**STAFF REPORT: 6/12/2023 REGULAR MEETING**

**APPLICATION NUMBER: #23-8394**

**ADDRESS: 12655 BROADSTREET (AKA RUSSELL WOODS PARK)**

**SCOPE: ALTER LANDSCAPING**

Figure 1, by Applicant: Proposed site plan showing pathway, new planting beds, benches and boulder locations.

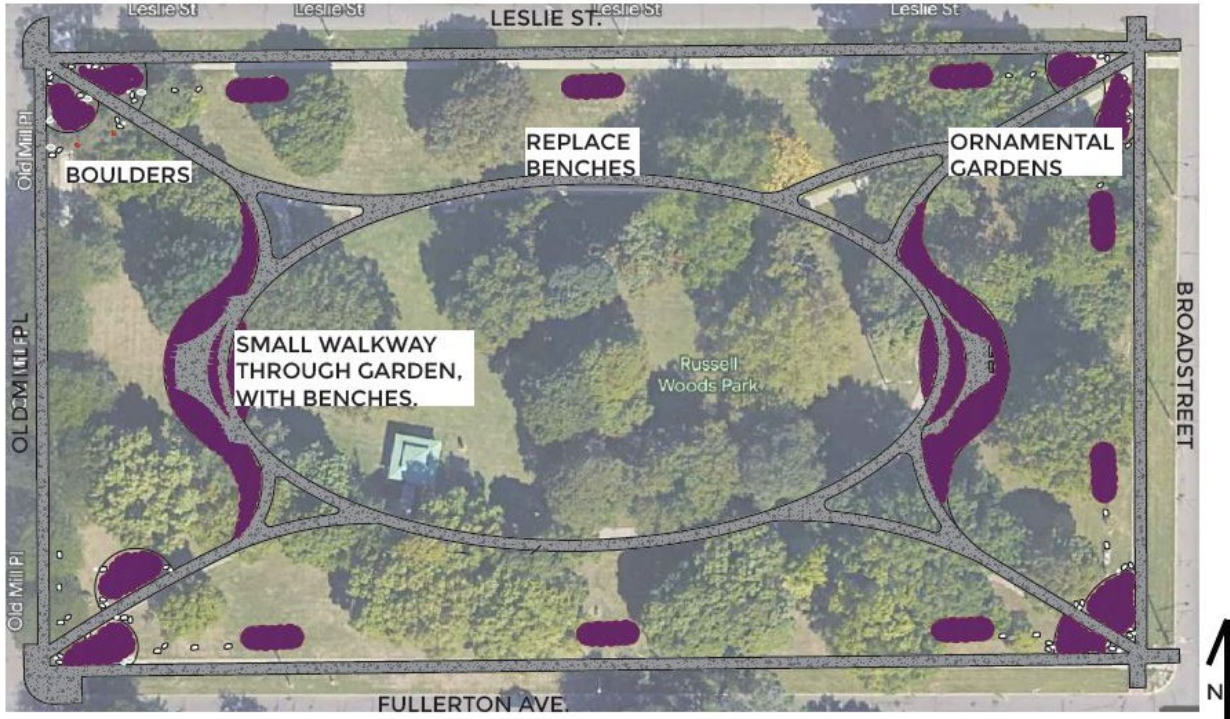
- The “tall steel standards” streetlights mentioned in the Elements of Design are not original lampposts. The proposed design has no changes to any existing lampposts.
- The proposed features do not conflict with the Elements of Design in materials or design. The benches, garden beds and boulders are appropriate materials.
- Staff has identified that the current configuration of the pathways, the mature trees, open lawn and passive use of the park are historic, character-defining features of the park. The proposal is in alignment with these elements and offers to restore planting beds that were once a part of the original

park plan. Staff has the opinion that this proposal supports and is in alignment with the historic character of the park.

It is staff's opinion that the project generally conforms to the Elements of Design for the district and meets the Secretary of the Interior's Standards for Rehabilitation. Staff therefore recommends that the Commission issue a Certificate of Appropriateness for the Master Plan as proposed.
